CONSTRUCTION INFRASTRUCTURE DRAWINGS CID-24-04		01	02	03	04	REVISIONS		DATE
TOWN OF ROLESVILLE CID-24-04 V2		01	02	03	04			
TOWN OF ROLESVILLE CID-24-04 V3								
TOWN OF ROLESVILLE CID-24-04 V4								
TOWN OF ROLESVILLE CID-24-04 V5								
TOWN OF ROLESVILLE CID-24-04 V6								
TOWN OF ROLESVILLE CID-24-04 V7								
TOWN OF ROLESVILLE CID-24-04 V8								
TOWN OF ROLESVILLE CID-24-04 V9								
TOWN OF ROLESVILLE CID-24-04 V10								
TOWN OF ROLESVILLE CID-24-04 V11								
TOWN OF ROLESVILLE CID-24-04 V12								
TOWN OF ROLESVILLE CID-24-04 V13								
TOWN OF ROLESVILLE CID-24-04 V14								
TOWN OF ROLESVILLE CID-24-04 V15								
TOWN OF ROLESVILLE CID-24-04 V16								
TOWN OF ROLESVILLE CID-24-04 V17								
TOWN OF ROLESVILLE CID-24-04 V18								
TOWN OF ROLESVILLE CID-24-04 V19								
TOWN OF ROLESVILLE CID-24-04 V20								
TOWN OF ROLESVILLE CID-24-04 V21								
TOWN OF ROLESVILLE CID-24-04 V22

RESERVE @ MITCHELL MILL
TOWN OF ROLESVILLE, WAKE COUNTY, NORTH CAROLINA
CONSTRUCTION PLANS
EROSION CONTROL PLAN OVERALL
PHASE 1 - STAGE 2

STRONG ROCK ENGINEERING GROUP		STRONG ROCK ENGINEERING GROUP, PLLC COMPANY LICENSE # P-2166 305 CHURCH AT NORTH HILLS STREET, SUITE

DRAWING SHEET
C-11.2

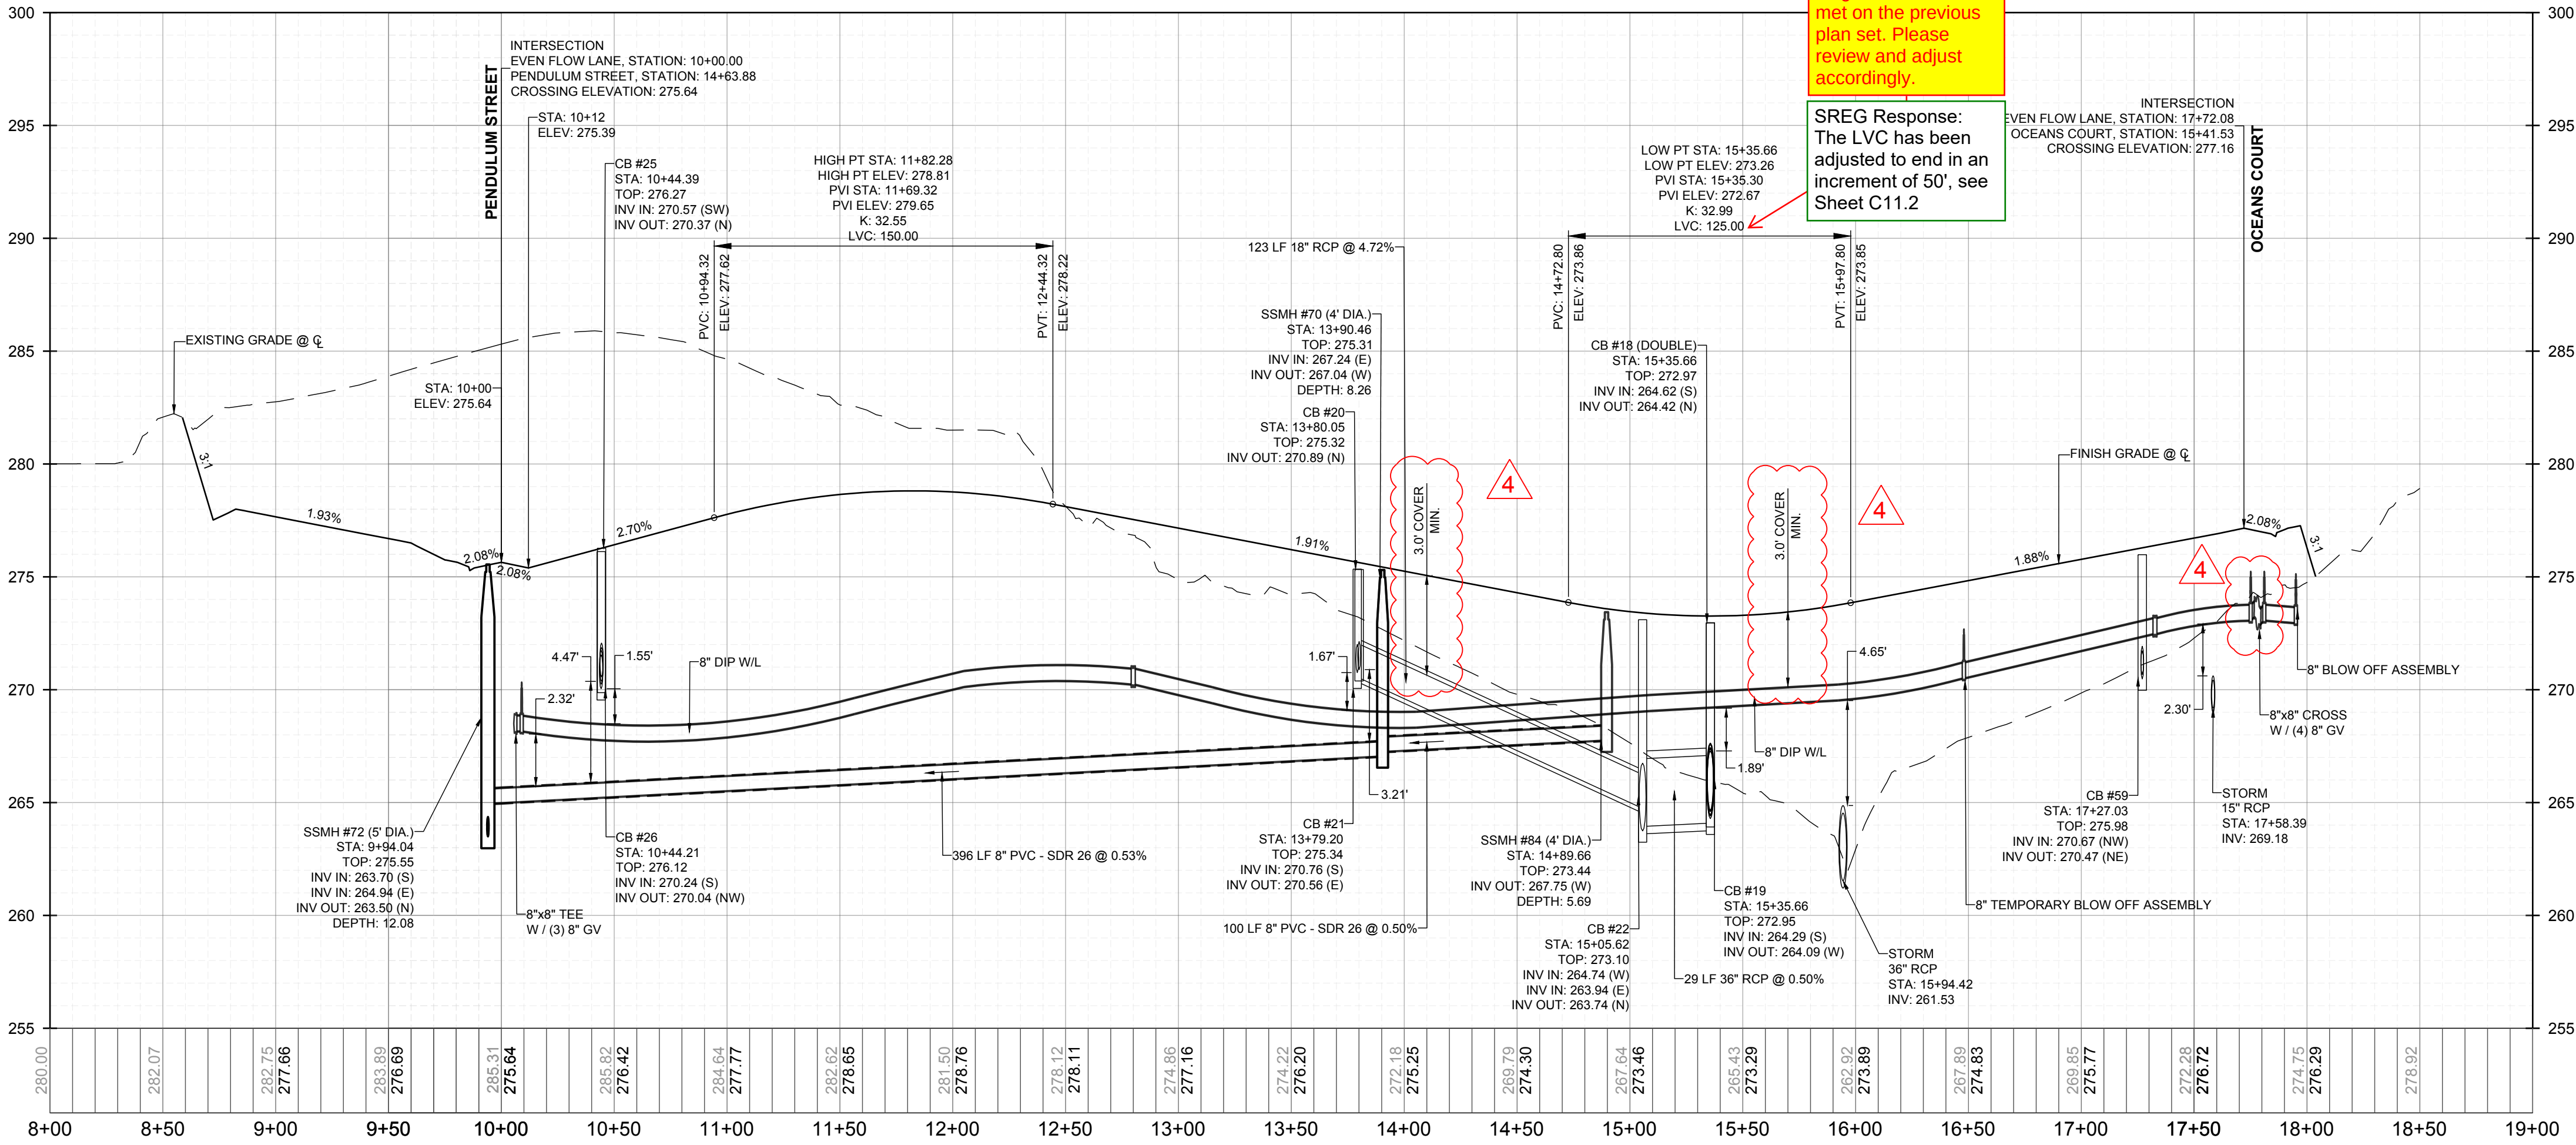
12 - The Town of Rolesville standards call for 50' increments for curve lengths. This was met on the previous plan set. Please review and adjust accordingly.

SREG Response: The LVC has been adjusted to end in an increment of 50', see Sheet C11.2

DRAWING SHEET
C-11.4

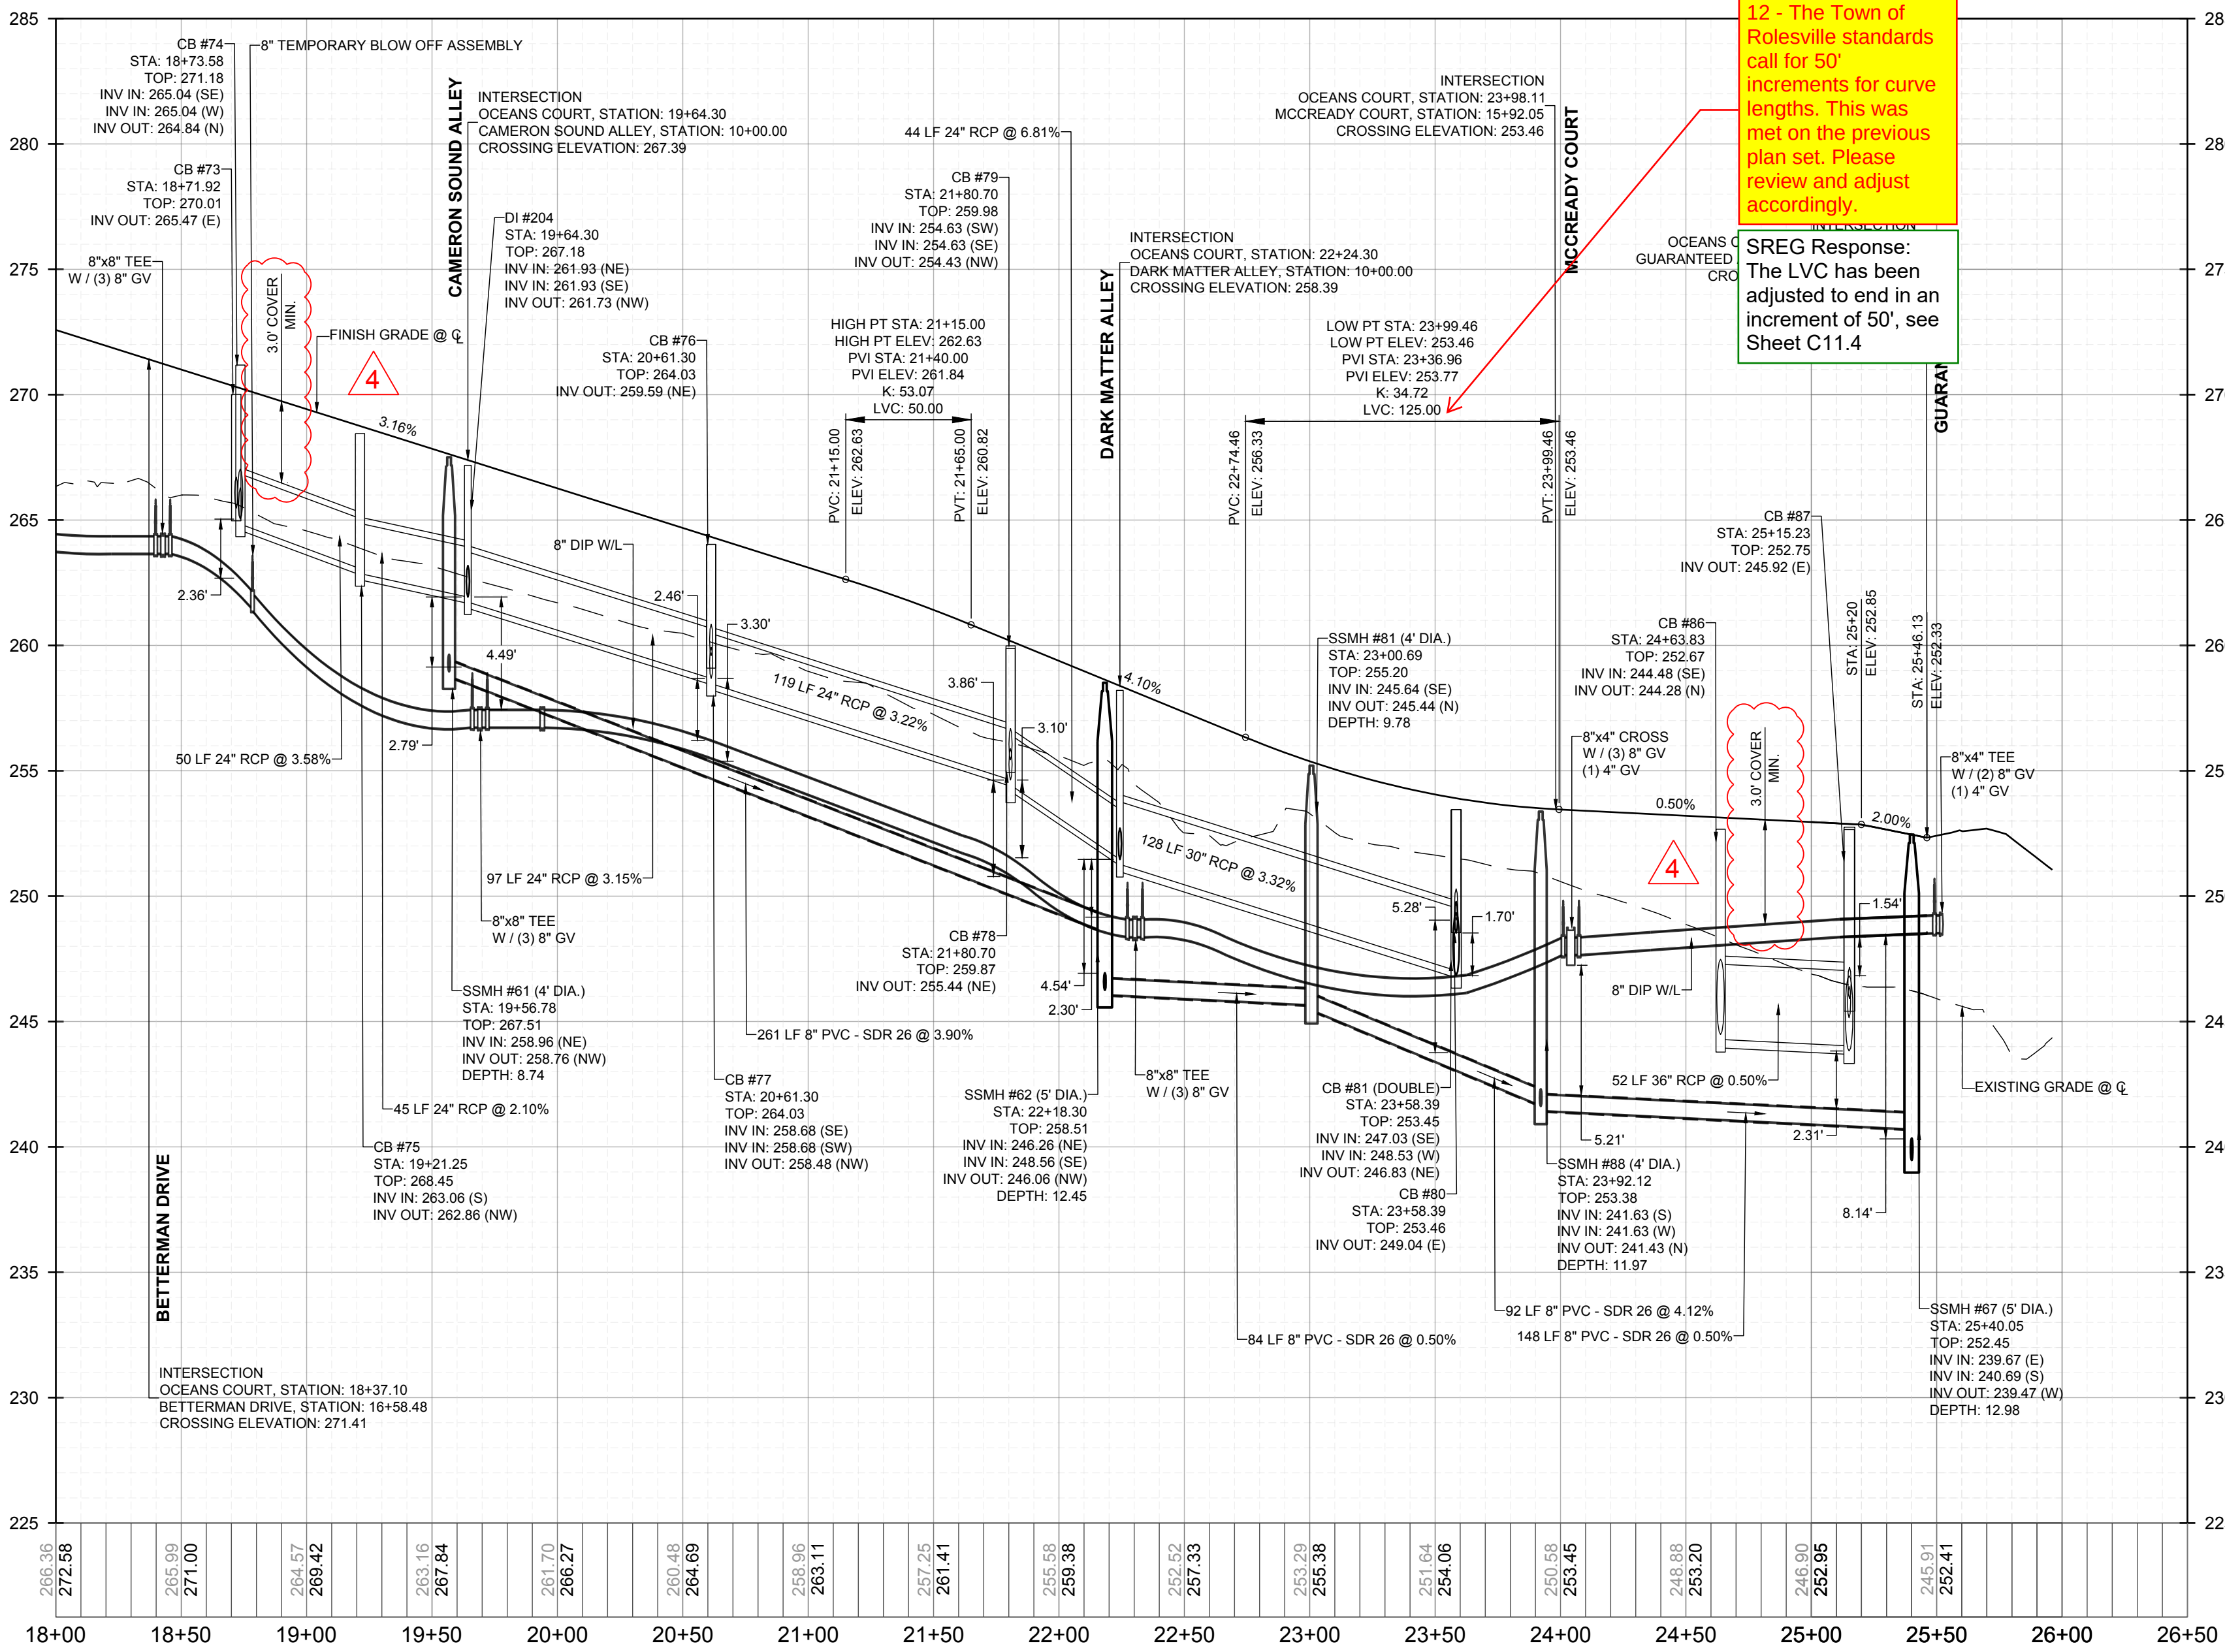
12 - The Town of Rolesville standards call for 50' increments for curve lengths. This was met on the previous plan set. Please review and adjust accordingly.

SREG Response: The LVC has been adjusted to end in an increment of 50', see Sheet C11.4
